## Product / Process Change Notification (PCN)

**PCN #:** PCN\_WL-TMRC\_20210123

**Affected Series:** 151031xxx

**PCN Date:** October 23, 2020

1. Product dimension

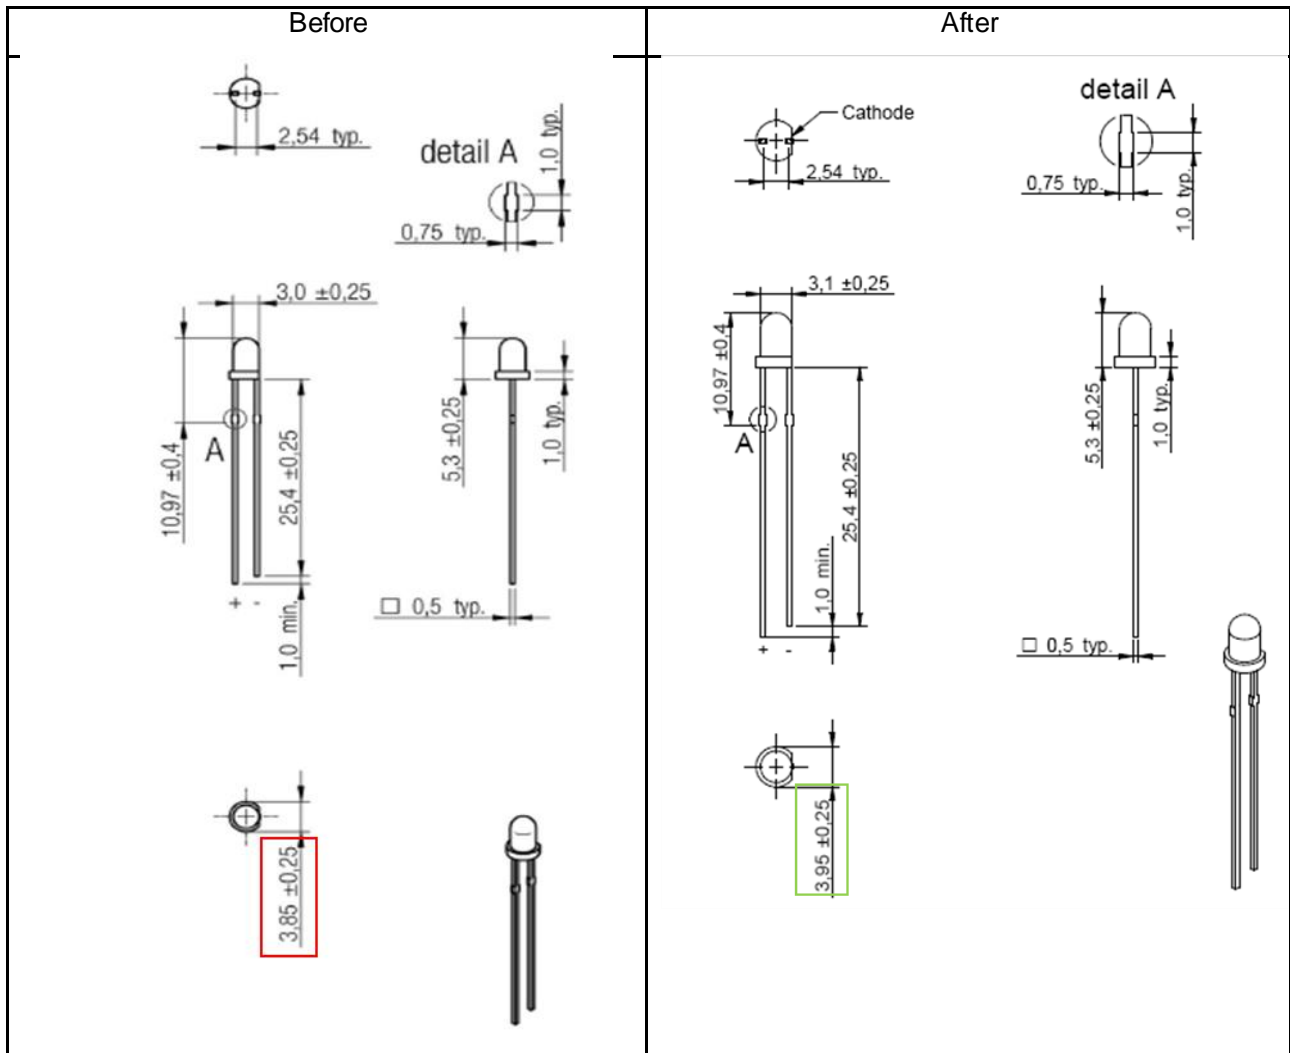
For improved performance of the lens shape, Würth Elektronik will change the dimension of the 3mm THT LED in the product family WL-TMRC. The electrical & optical parameter and material of products will not change.

There will be no change in fit, function, quality or reliability of the product.
